TITLE: TLD5542-1HIPOW_EVAL

Document Number: REV: S03

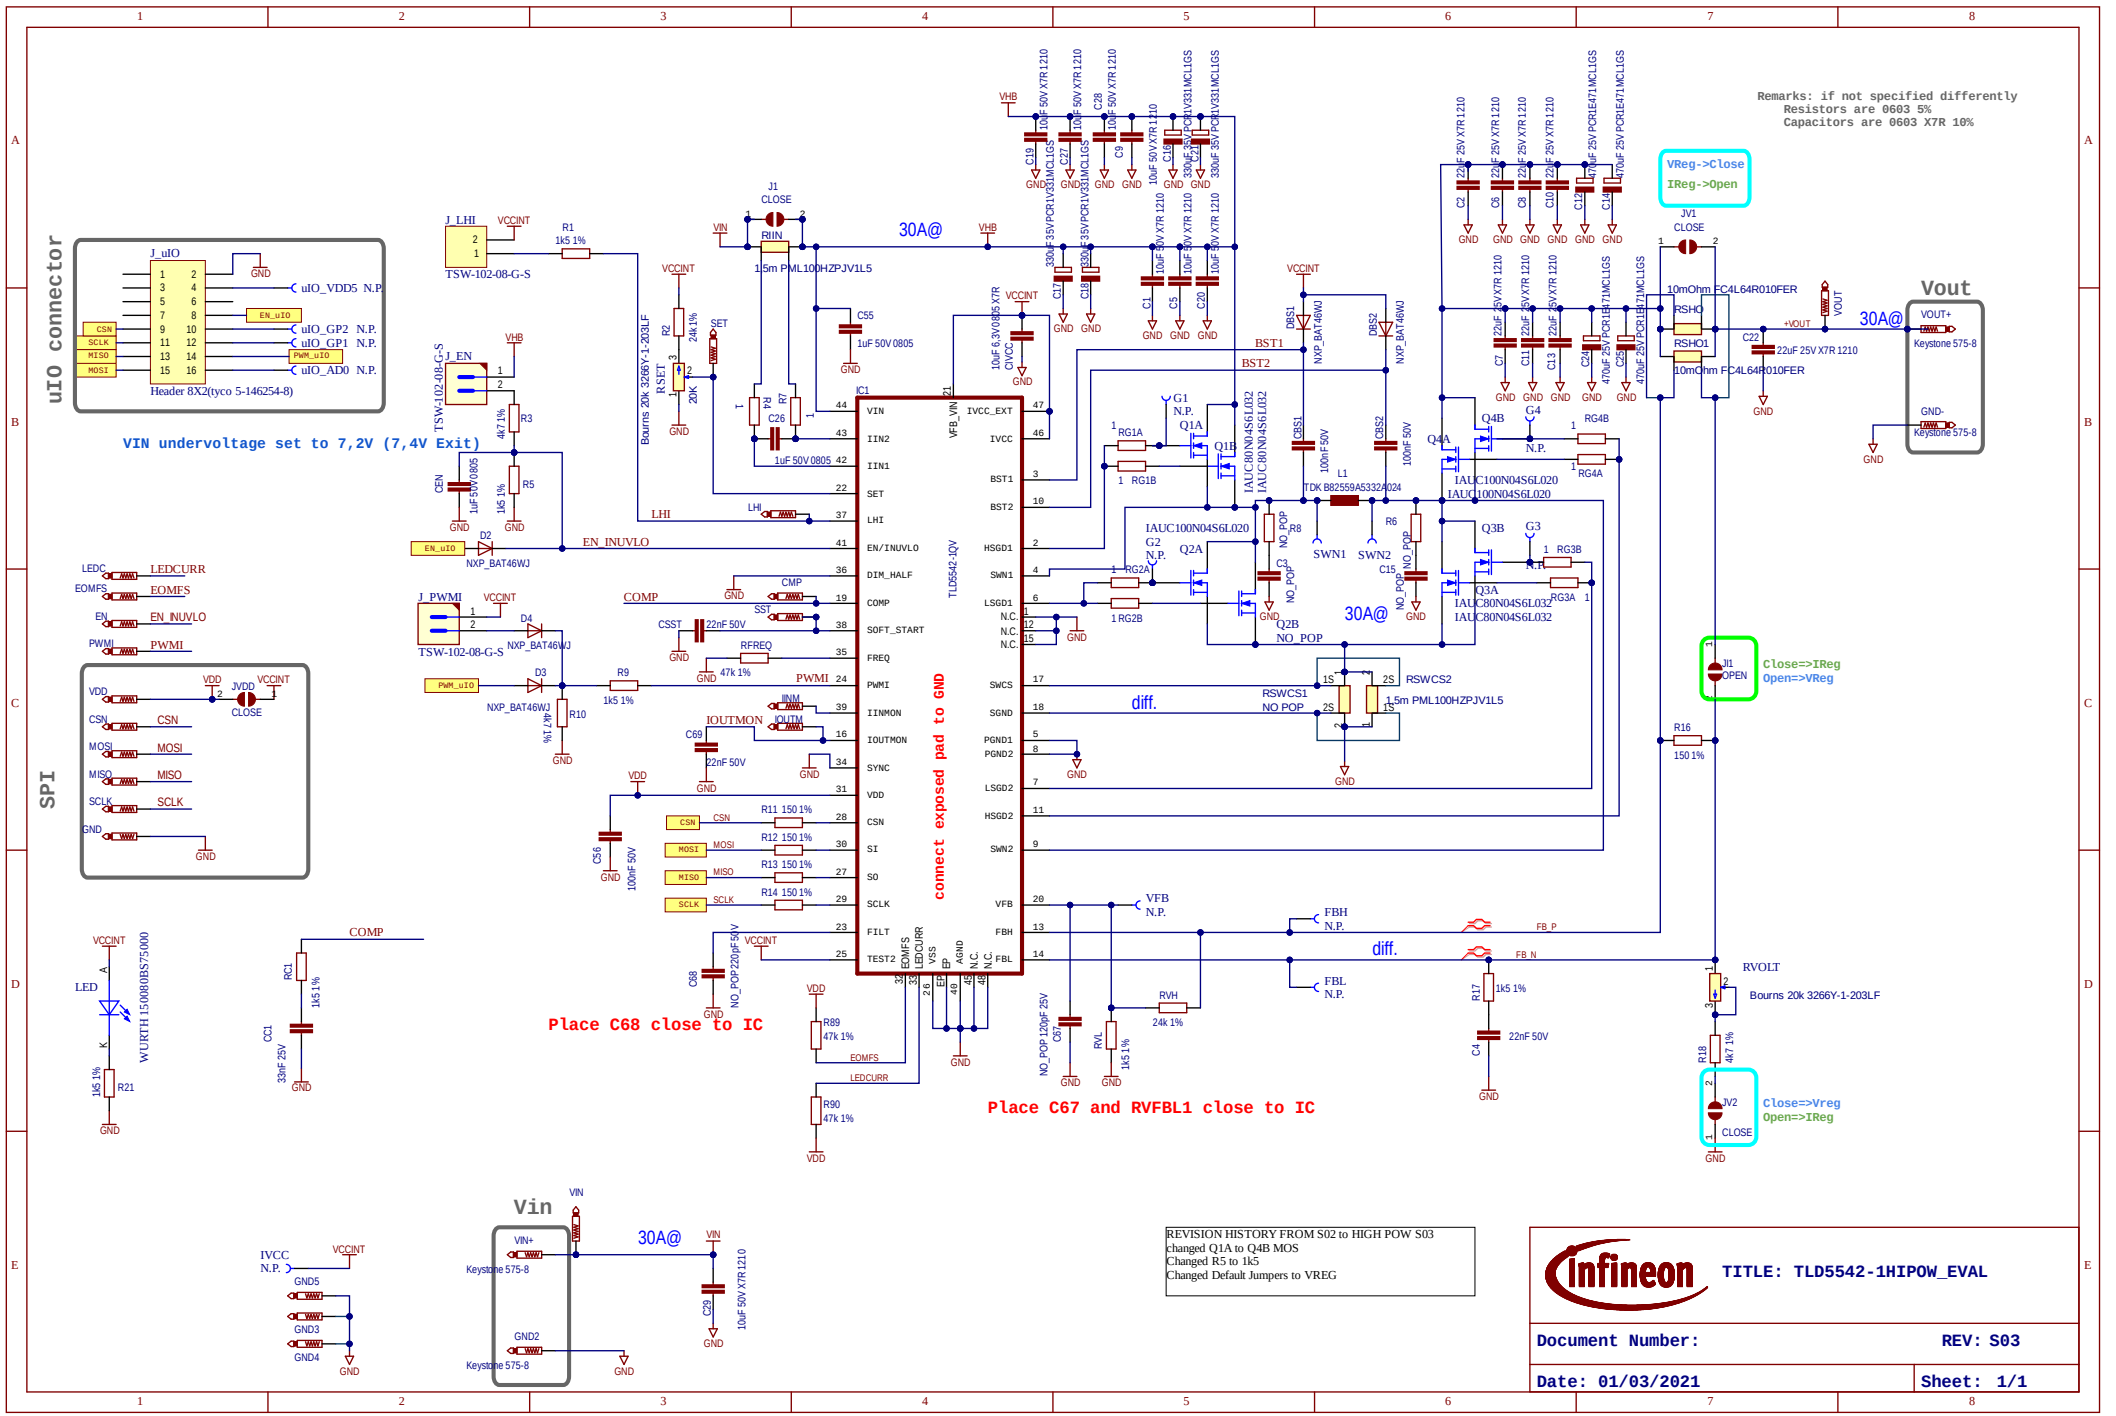
REVISION HISTORY FROM S02 to HIGH POW S03
changed Q1A to Q4B MOS
Changed R5 to 1k5
Changed Default Jumpers to VREG
